### **AMENDMENTS TO THE DRAWINGS**

## REMARKS

ANNOTATED SHEET SHOWING CHANGES

FIG. 2

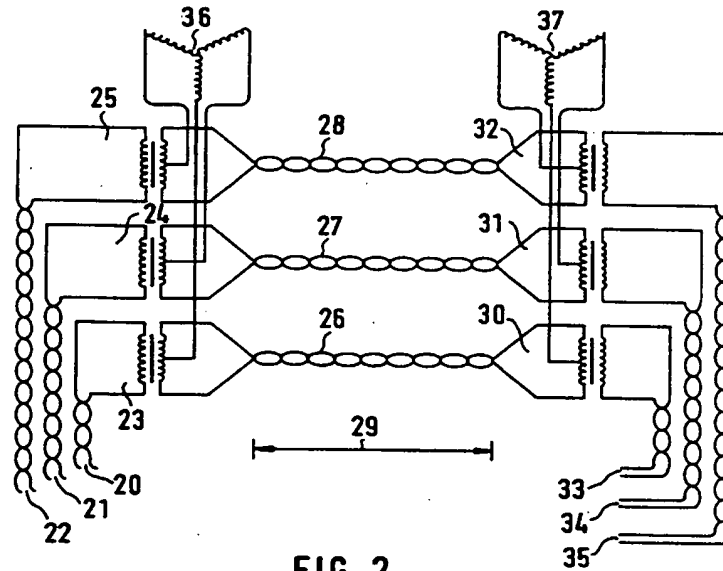
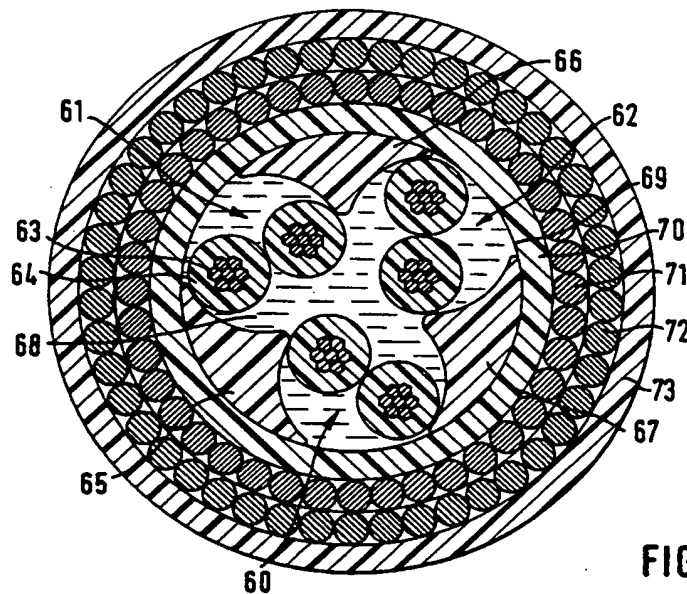
For purposes of further explaining the distinctions between Hassel and the present invention, Hassel Figure 2 and Figure 4 are included herein and represent the three (3) phase system of Hassel. Referring to Hassel Figure 2 the twisted cable pairs 26, 27, 28 that carry the power and communications signals. Referring to Hassel Figure 4, each of the twisted cable pairs 60, 61, 62 have two conducting members that are either stranded or solid copper conductors. "The basic idea is to use three insulated twisted pairs as a three phase cable .... Each pair is connected in parallel for the power transmission, and each pair is used as a signal pair for signal transmission." (Hassel, Col. 2, lines 50-54)

Furthermore, Hassel specifically recites the benefits of the twisted pair configuration, wherein "[t]wo insulated conductors are twisted in a pair configuration to improve signal crosstalk and the power (harmonic) related noise immunity during normal operations and

transient conditions. Each twisted pair will act as one power phase as the conductors are connected in parallel.” Thus the present invention teaches away from the Hassel reference by using single conductor elements and not twisted pairs.

Fig. 2

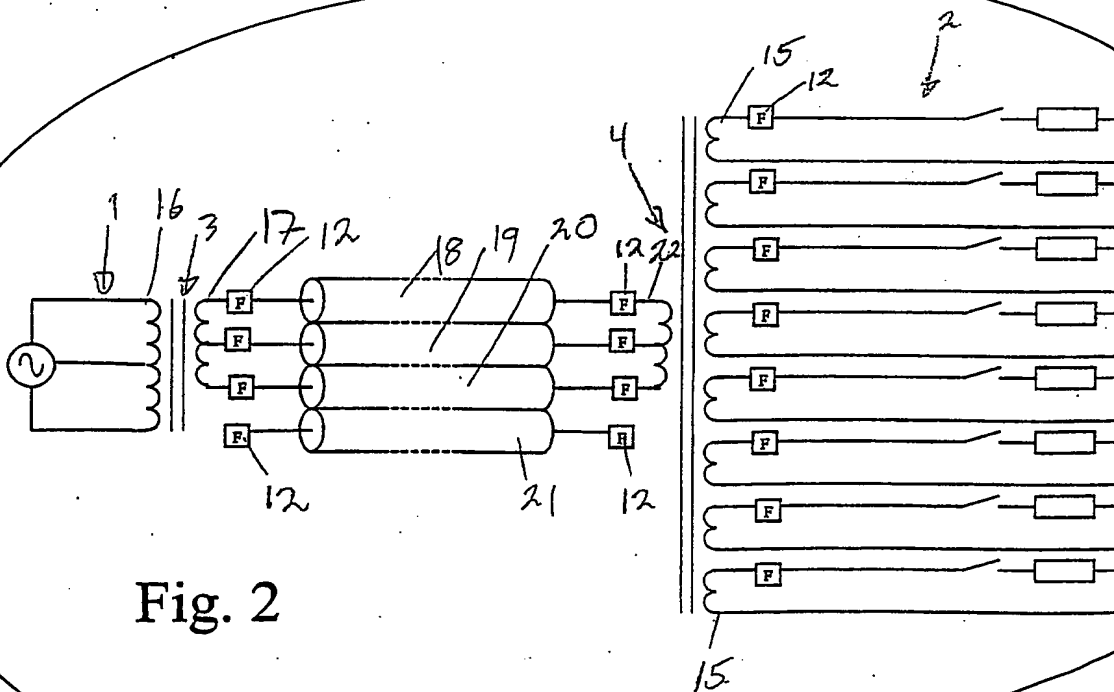
Fig. 2 has been moved to a  
Separate sheet - 2/3

\* Figs. 3, 4 and 5 have  
been amended to show  
proper cross-section  
hatching according to  
MPEP Section 608.02  
and as required by the  
Examiner

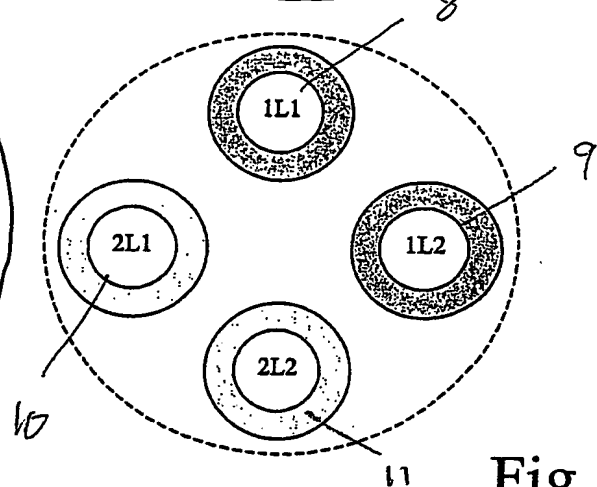
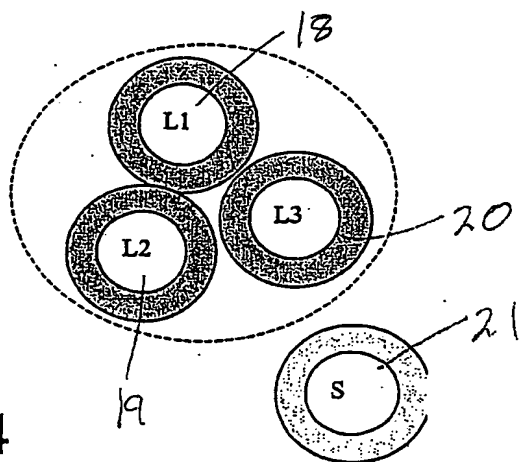
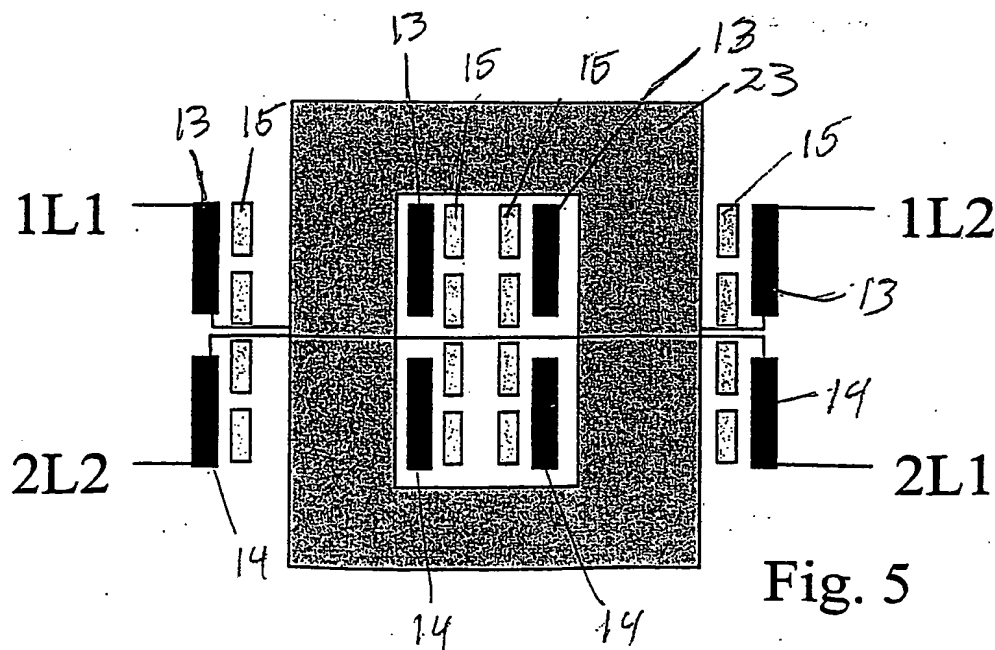
The original drawing sheet 2/2 included Fig. 3, Fig. 4 and Fig.5. These figures have been formalized and amended to show proper cross-section hatching according to MPEP Section 608.02 and as required by the Examiner. Figs 3-5 are now on replacement sheet 3/3 which replaces the original sheet 2/2.

The Office has objected to the Drawings because they do not have cross-section hatching according to MPEP 608.02. Replacement sheets for figures 1-5 are included herein and the rejection is traversed.
